Docket Items #10 & #11  
BAR CASE # 2017-0098 & 0103

BAR Meeting  
April 19, 2017

**ISSUE:** Permit to Demolish/Capsulate for partial demolition and Certificate of Appropriateness for alterations

**LOCATION:** 1100 King Street

**D2.01**

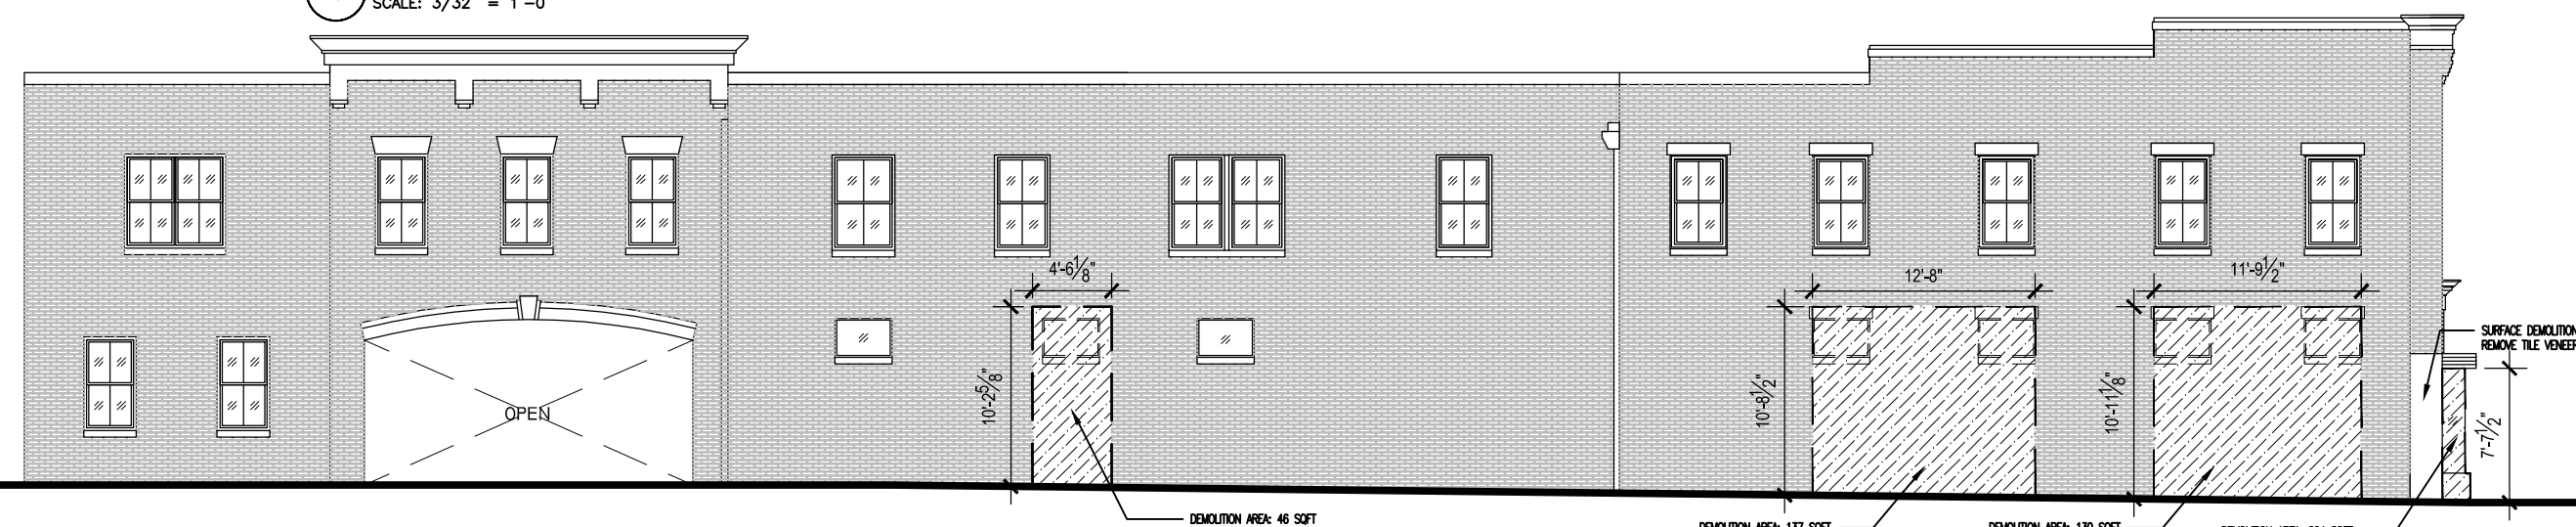
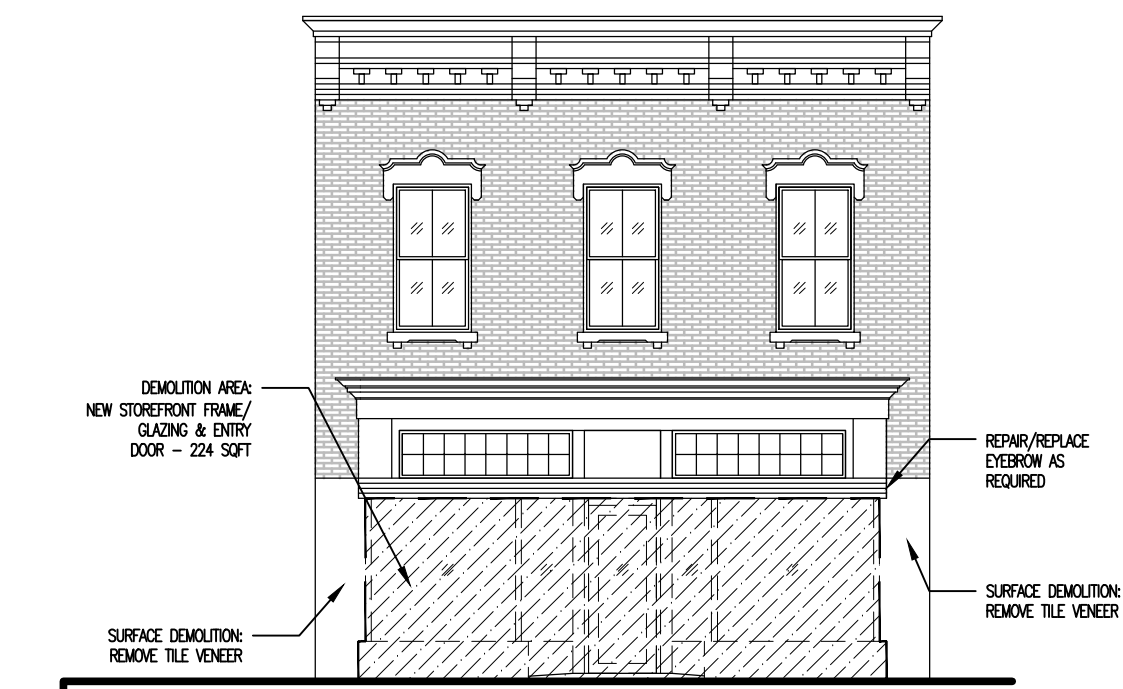
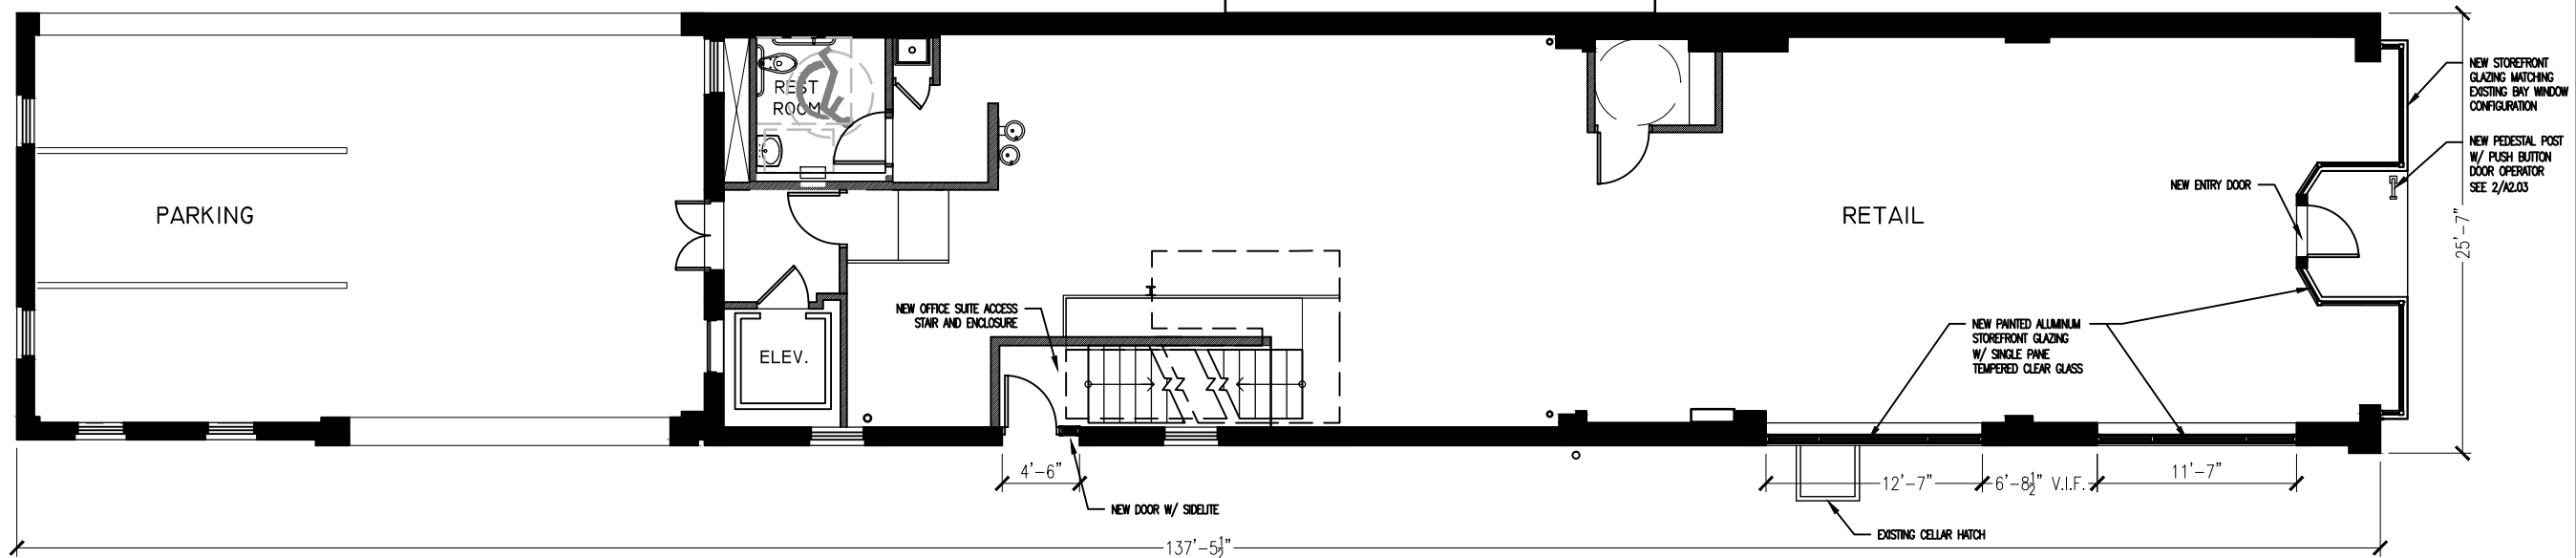
Two sections at the north end of the east wall at the southwest corner of South Henry Street and King Street, measuring approximately 129 square feet and 136 square feet respectively and including a total of five small original transom height windows, will be demolished to accommodate two new storefront windows. Further south on the east elevation a smaller section of wall (approximately 46 square feet) will be removed for a single entry door.

In the opinion of staff, none of the criteria for demolition and capsulation are met and the Permit to Demolish/Capsulate should be granted. The relatively small sections of wall where the demolition is proposed are on a secondary elevation constructed of common brick which has been altered in the past, as evidenced by inconsistent brick work in these areas. While the two new storefront windows and entry door remove a total of five small windows that align with the second floor windows above and may be early 20<sup>th</sup> century openings dating to the commercial conversion of the original residential structure, they are minor architectural features on a secondary façade. They are not character-defining features on this Italianate style building, are not of uncommon design or historic merit, and do not compromise the integrity of the building as a whole. Staff recommends approval of the Permit to Demolish/Capsulate as submitted.

SHEET NUMBER	PROJECT TITLE	
	1100 KING STREET - B.A.R. SUBMITTAL	
	PROJECT NUMBER	
A3.01	17_001	SHEET TITLE
	DATE	
ALEXANDRIA OFFICE		CROSS SECTION
911 King Street, Alexandria, Virginia 22314 ph: 571-327-1723 fx: 703-548-4305

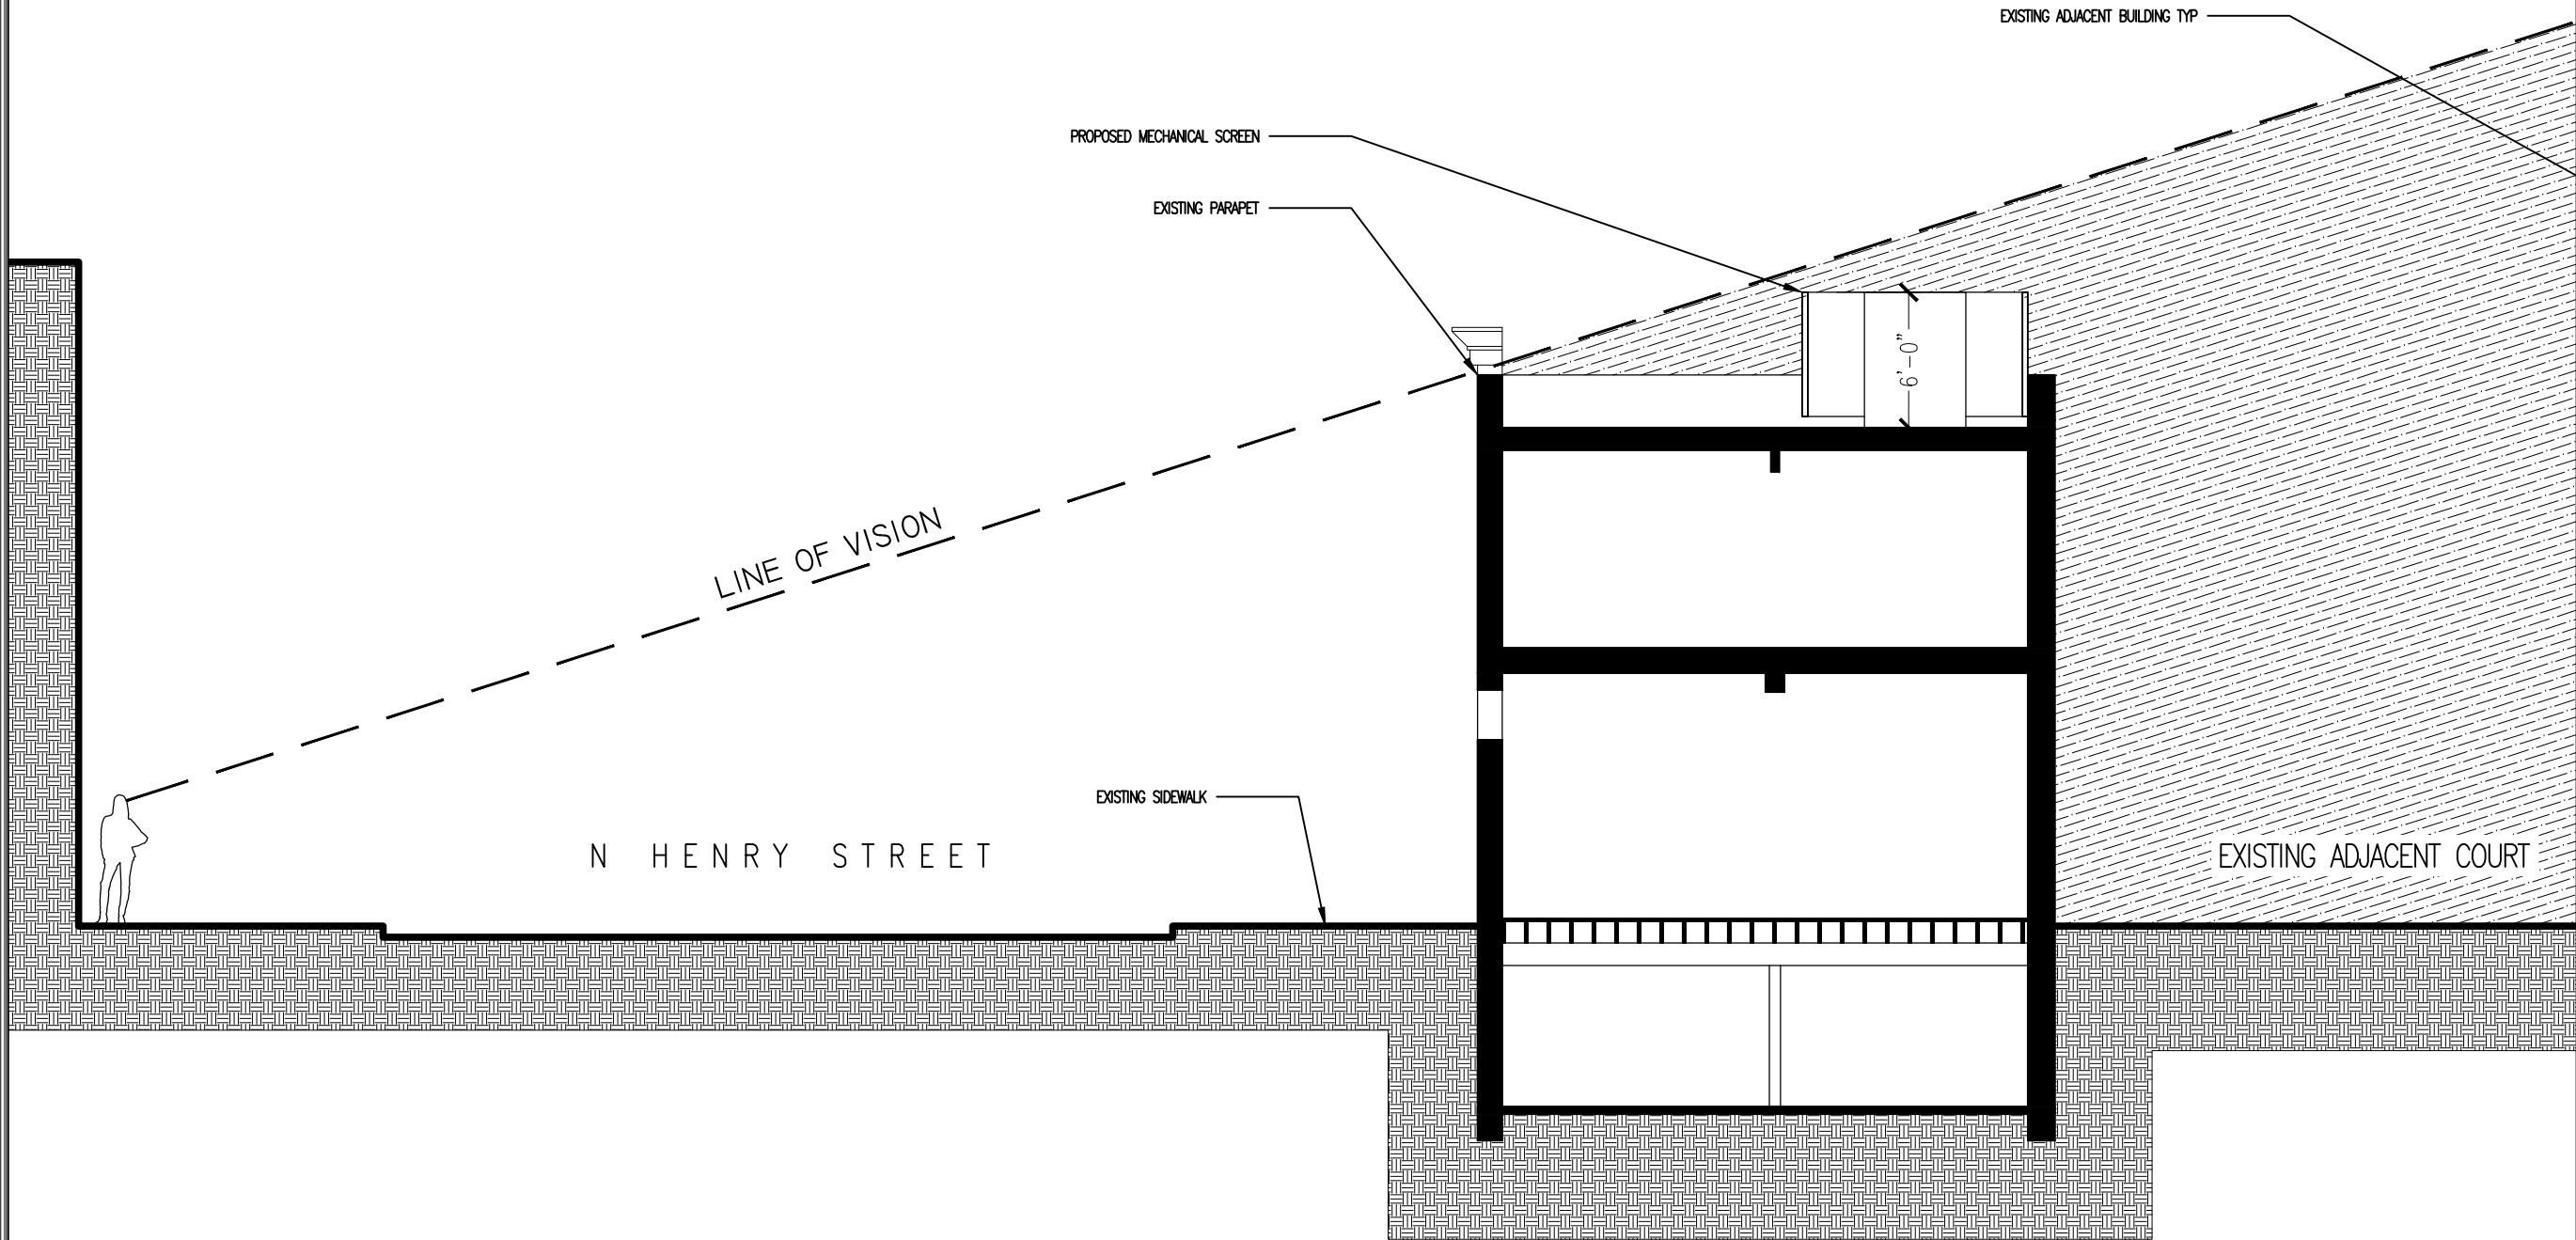
Finally, staff supports location of the mechanical equipment to a less visible location. Although neither the equipment nor the screening should be visible to a pedestrian on Patrick Street (see Sheet A3.01), staff nevertheless suggests that it be painted a light, neutral grey color to blend with the sky with the final approval of the screening material and color to be approved by staff during building permit review.

Staff recommends approval of the Permit to Demolish/Capsulate and the Certificate of Appropriateness with the condition that final approval of the rooftop mechanical equipment screening material and color be approved by staff during building permit review.
